June 18, 2010

File No.: P10069

**Re: Peer Review Brief
Proposed development at southeast corner of Victoria and Napier
Thornbury Community**

Figure: Suggested priority unit locations

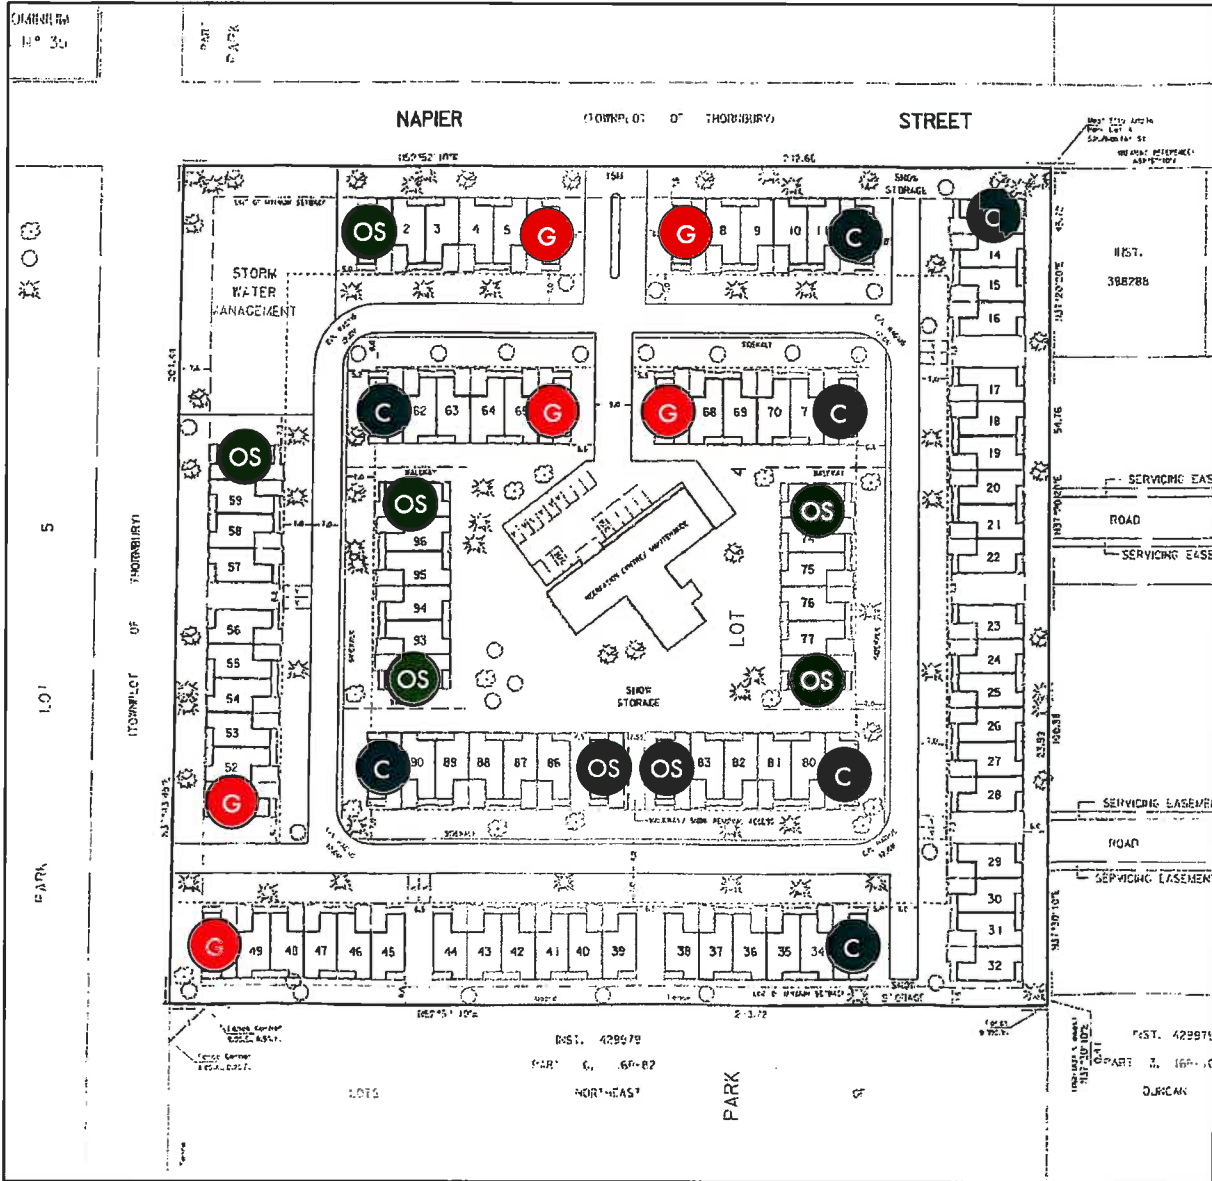
- (5) **The “priority units” in the proposed development concept, from a neighbourhood design perspective, should have a higher level of elevation design, articulation and detailing.** Priority units are those units that given their specific location or context in the overall development are highly visible and represent focal points within a neighbourhood. Priority units deserve a particular emphasis in terms of articulation, massing, and detailing to ensure they appropriately reflect their prominent locations in the neighbourhood. We would suggest three different types of priority units exist in the proposed development concept: gateway units; corner units; and open space units (see the following page for illustrative purposes only as we suggest a redesign of the site).

Considerations for the elevations of priority units should include: providing similar side elevations to that of the front elevation in terms of detailing for units publicly visible on two side yards; using increased height and massing; incorporating enhanced fence design for the sides that are publicly visible; using increased height and massing to emphasize the unit; wrapping porches around the building façade on corner units; and using different materials and colours to differentiate the units.

- G Gateway units
- C Corner units
- OS Open space units
